Proposed Amendment No. 101D

Letter from C. R. Steinhardt (WPSC)

Affected TS Pages

Figure TS 3.1-4

**FIGURE TS 3.1-4
LOW TEMPERATURE OVERPRESSURE PROTECTION CURVE
APPLICABLE FOR PERIODS UP TO END OF OPERATING CYCLE 20**

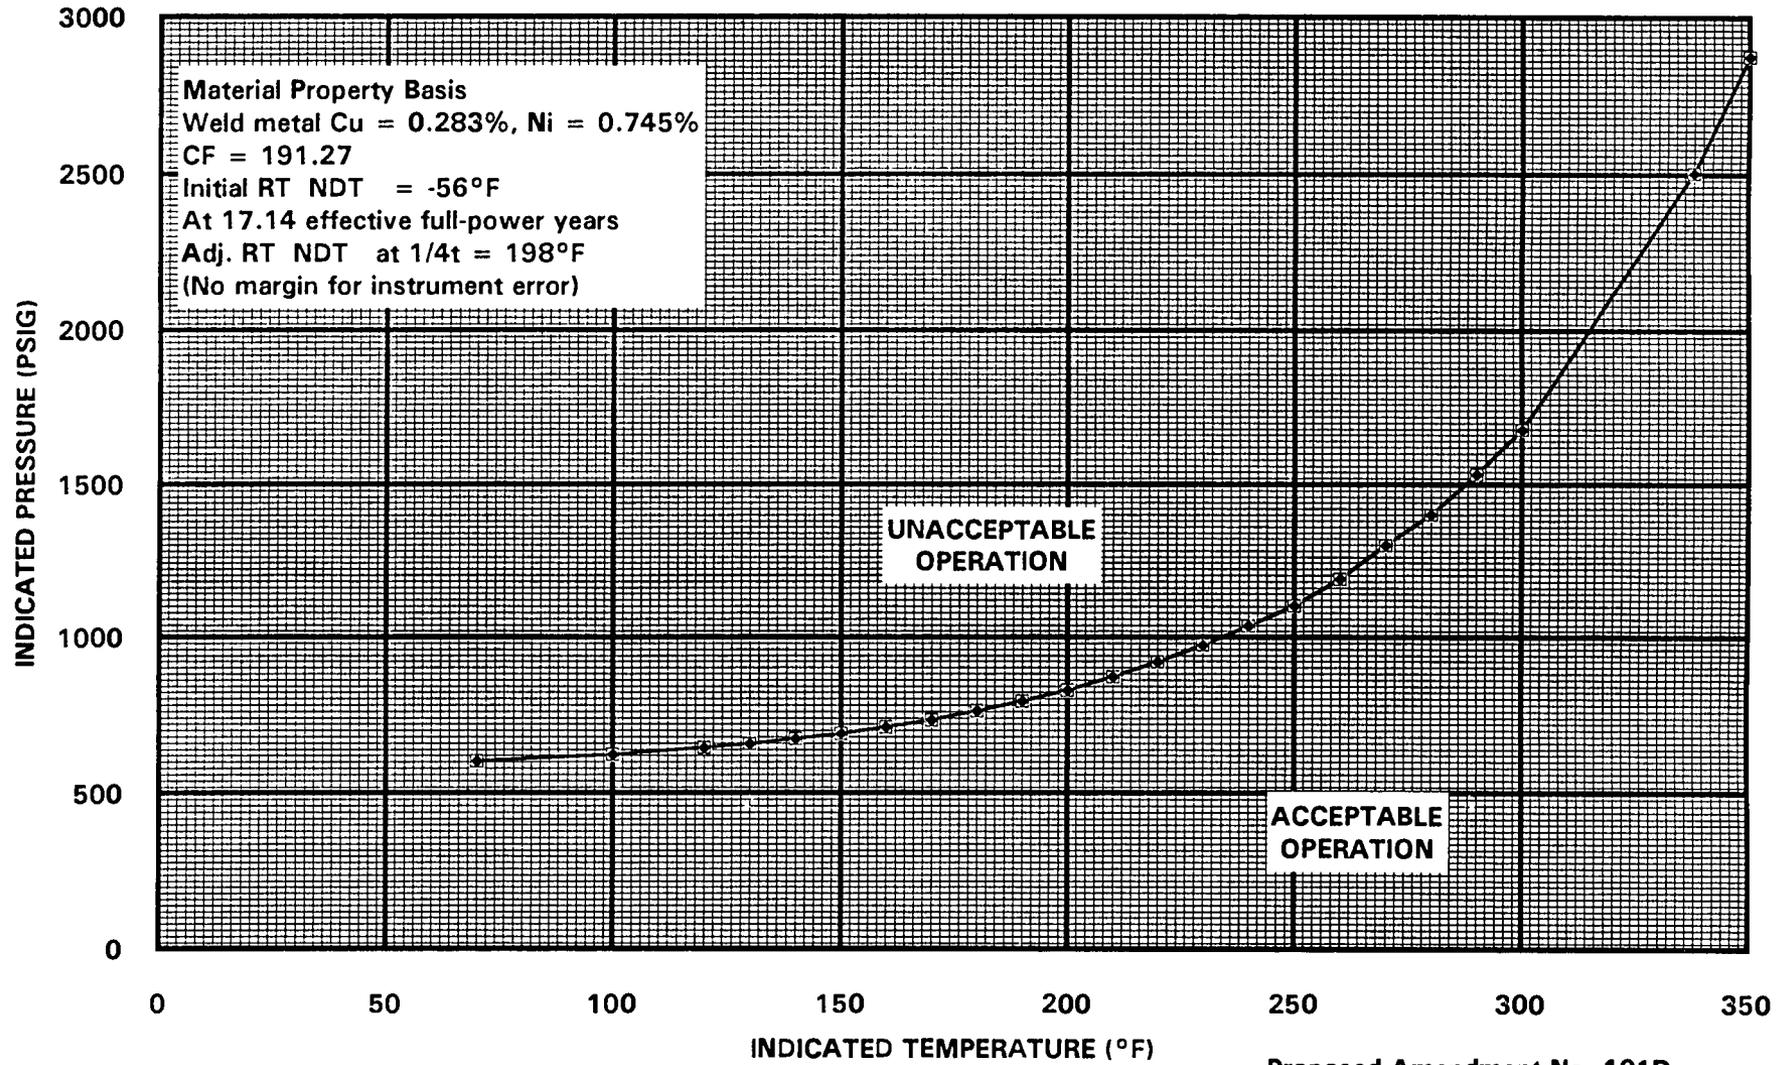
- C. Figure TS 3.1-4 defines limits to assure prevention of non-ductile failure applicable to low temperature overpressurization events only. Application of this curve is limited to evaluation of LTOP events whenever one or more of the RCS cold leg temperatures are less than or equal to the LTOP enabling temperature of 338°F.

A limit curve (Figure TS 3.1-4) for evaluation of low temperature overpressure protection (LTOP) events has been calculated using the methodology of Regulatory Guide 1.99, Revision 2, Position C.2. The derivation of the LTOP evaluation curve is consistent with Footnotes (15)(16). This curve is applicable for 17.14 effective full-power years of fluence (through the end of operating cycle 20). If a low temperature overpressure event occurred, the RCS pressure transient would be evaluated to the limits of this figure to verify the integrity of the reactor vessel. If these limits are not exceeded, vessel integrity is assured and a TS violation has not occurred.
